CONSERVATION DEPARTMENT DETAILED AGENDA

SCC Meeting Date:

March 10, 2022

AS-BUILT SITE PLAN
WITH PROPOSED REMEDIATION

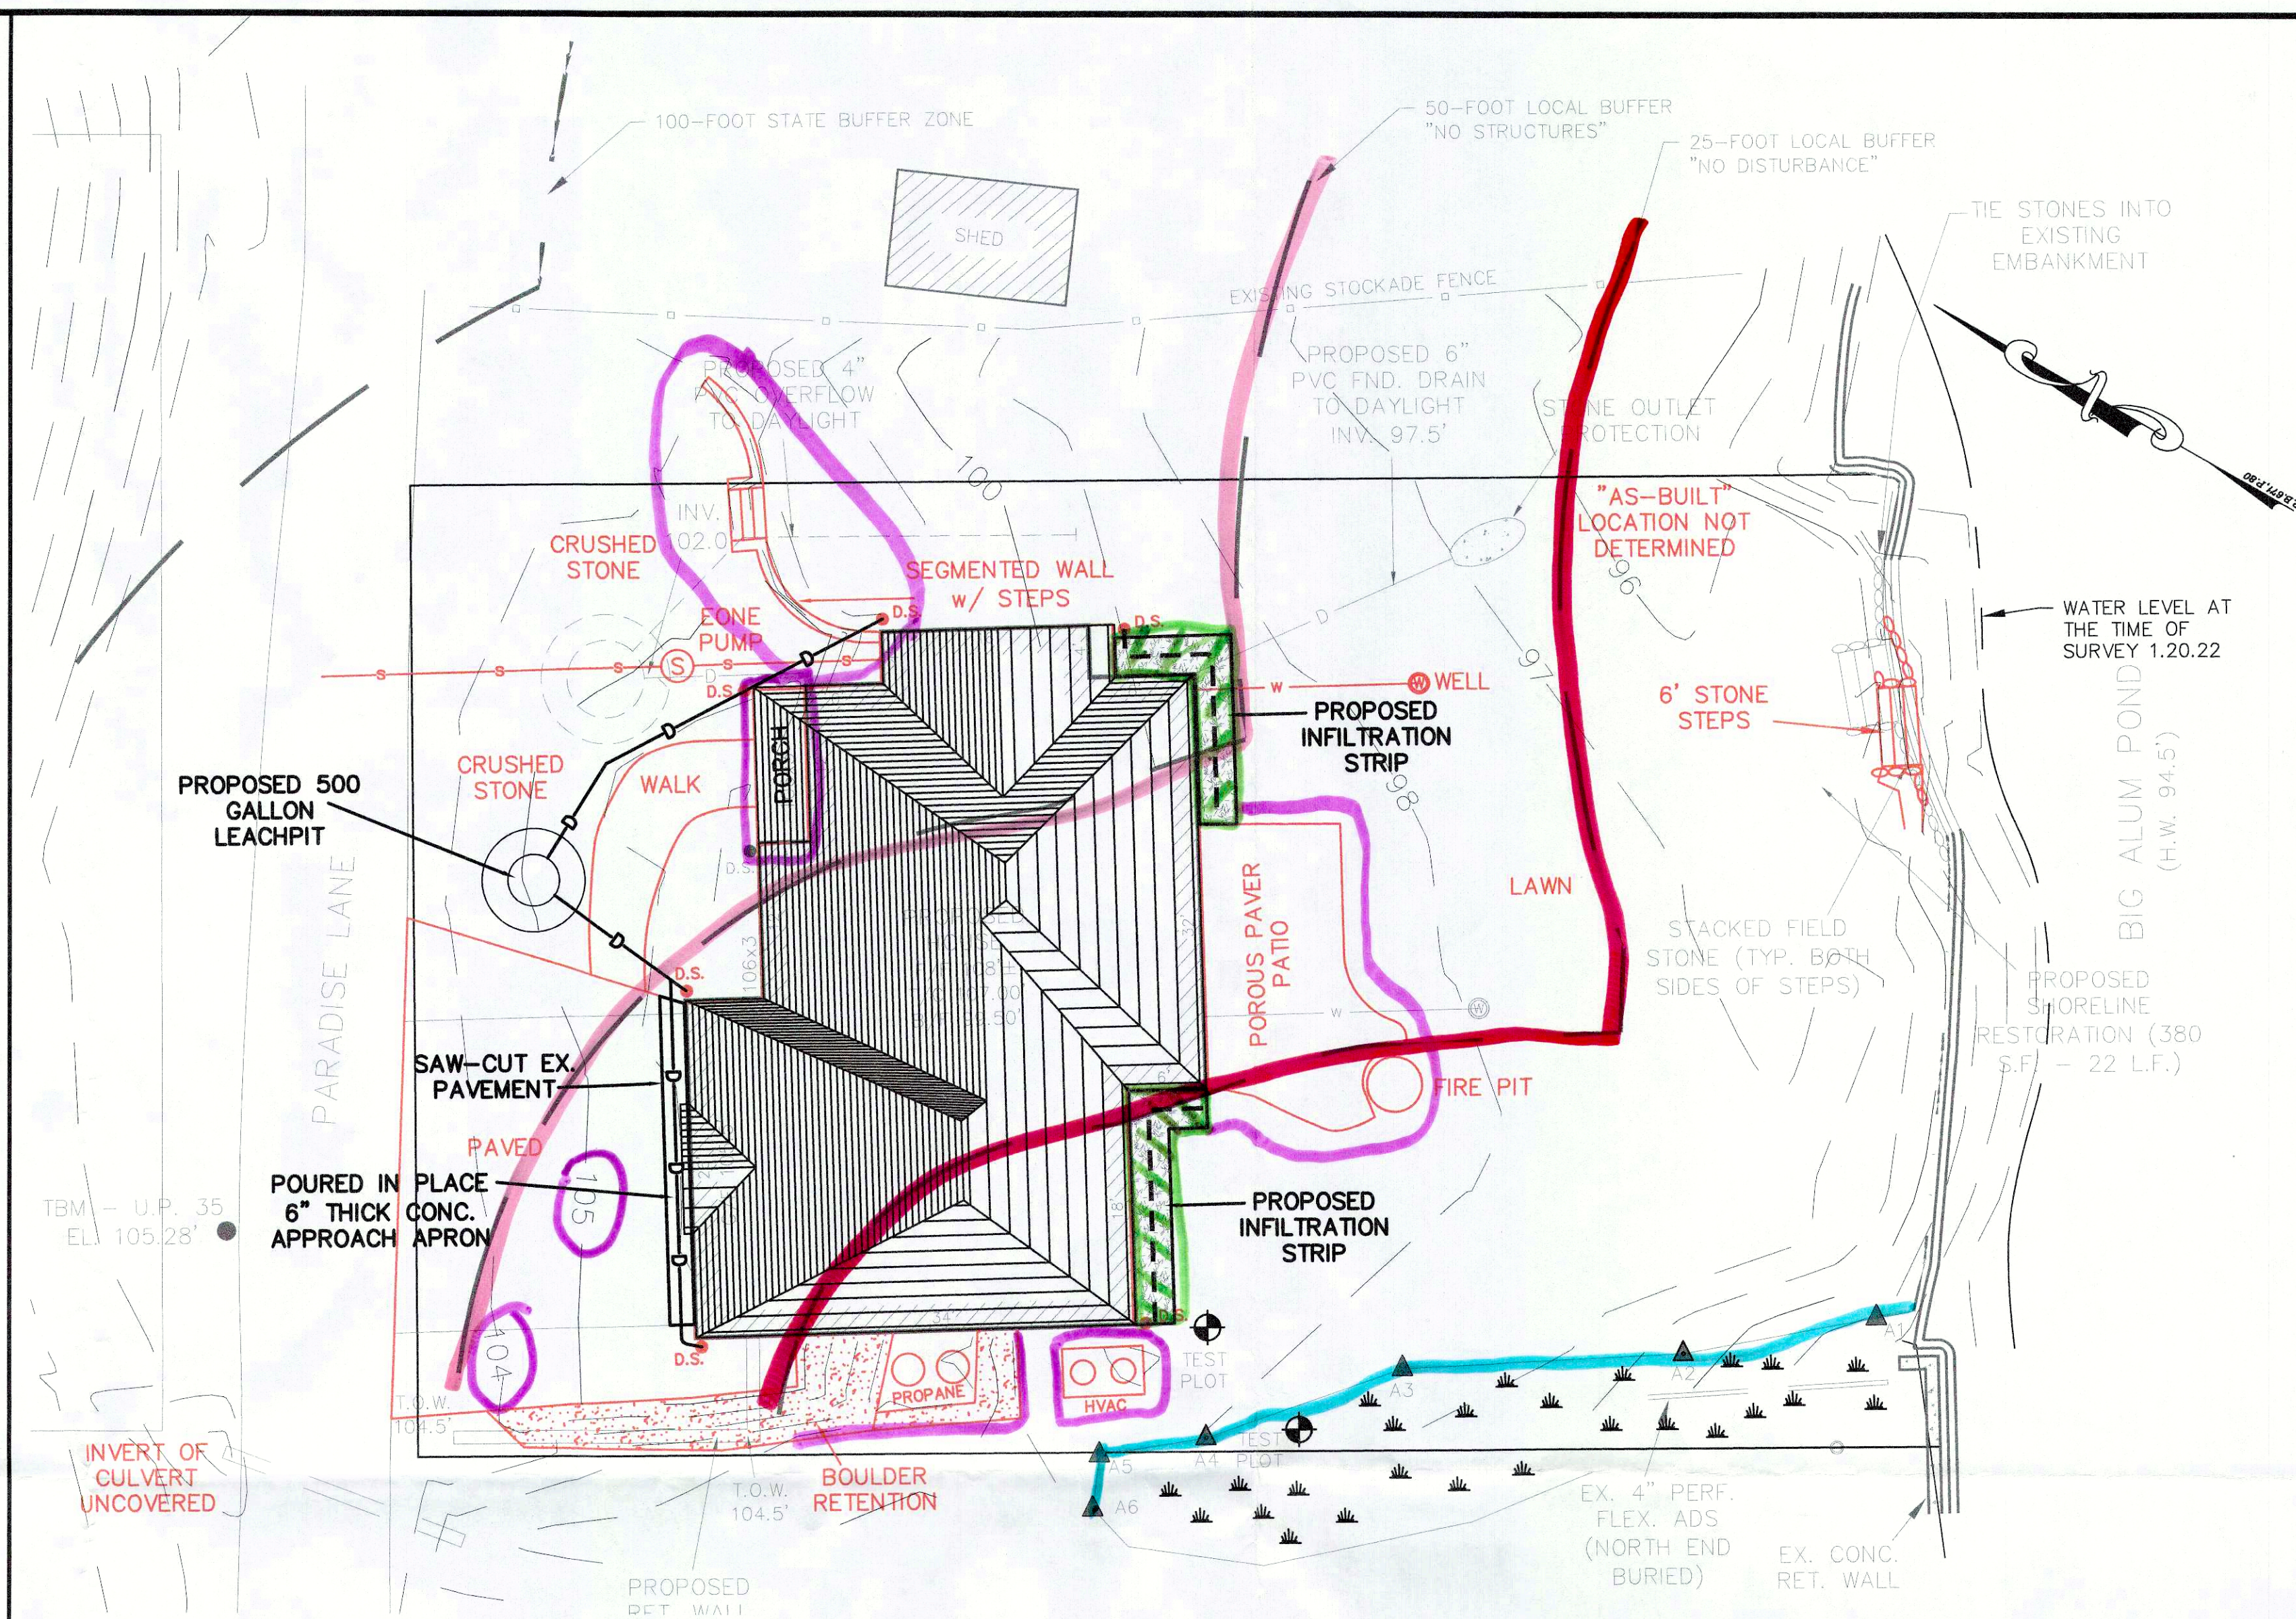
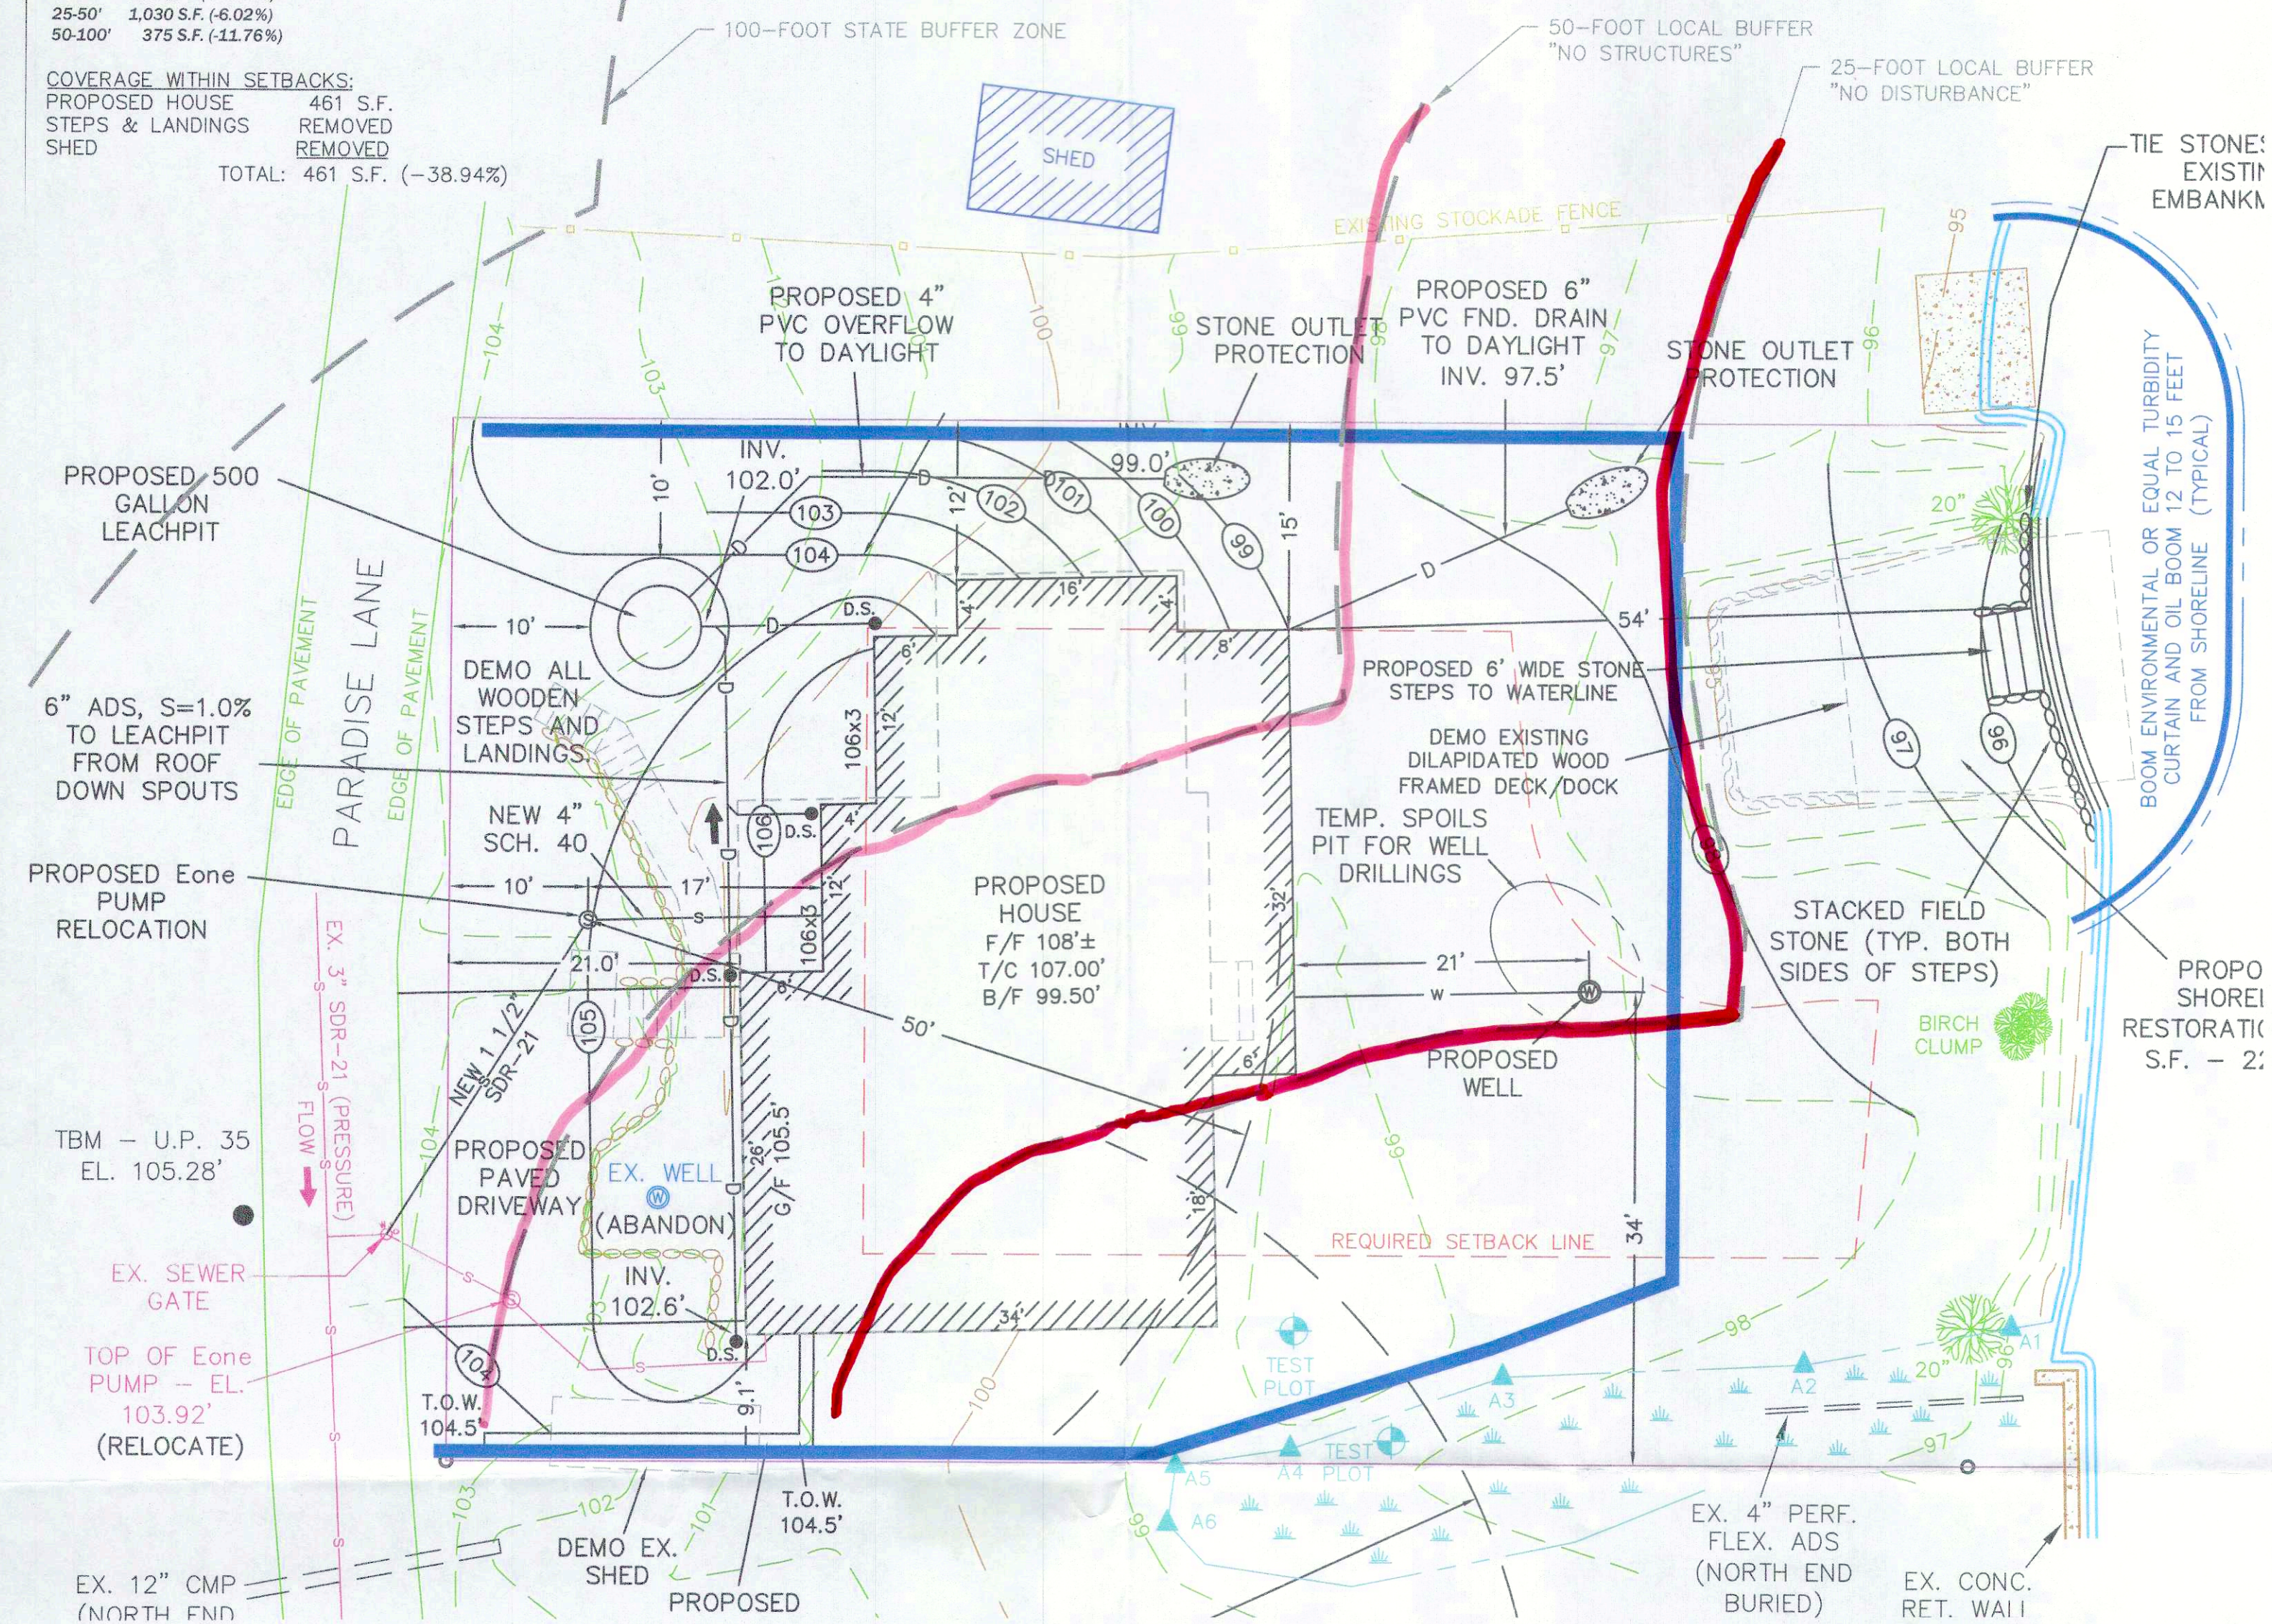
Staff Notes: A revised plan has been submitted to address the SCC's comments at the last meeting. Plan includes adding roof runoff infiltration along the house. Options to improve runoff across the street were also discussed. Plantings had been required as part of the original OOC. These have not been installed. Review of the plan shows that additional work occurred within the 25 ft. BZ including a patio, HVAC unit install and boulder retention area. The HVAC unit is located within 3 feet of the wetland. In addition, it appears that the house may have expanded slightly (new porch added) and all the contour lines have changed on site. Of concern is the driveway which originally pitched towards the house but now has been raised and pitches towards the road. The stormwater here now being directed towards the road versus on site.

Staff Recommendations: Roof runoff infiltration will be an improvement. The board should evaluate if they do see that additional BMPs across the street would be warranted or not and advise the property owner. The board needs to also consider the additional work adjacent to the BVW to see if that would have been allowed or should be moved away from the wetland. The on-site BVW should be evaluated to ensure that it hasn't been impacted. After SCC discussion and input on any project changes requirements needed, an application is required for work not previously permitted and/or to occur now. The 8 required shrubs outlined in the NOI must be installed. The locations shall be shown on the plan. The SCC should make recommendations on their locations. Should be planted to near the BVW in the 25 ft. setback from that wetland and near the lake shore. It appears that this area is being used as dock storage/yard. A vegetated naturalized buffer here would be advisable. The 3 trees are still on site from the original plan. **Recommend board site visit to review site to assist with developing requirements, etc. Next site visit date is 3-22-2022.**
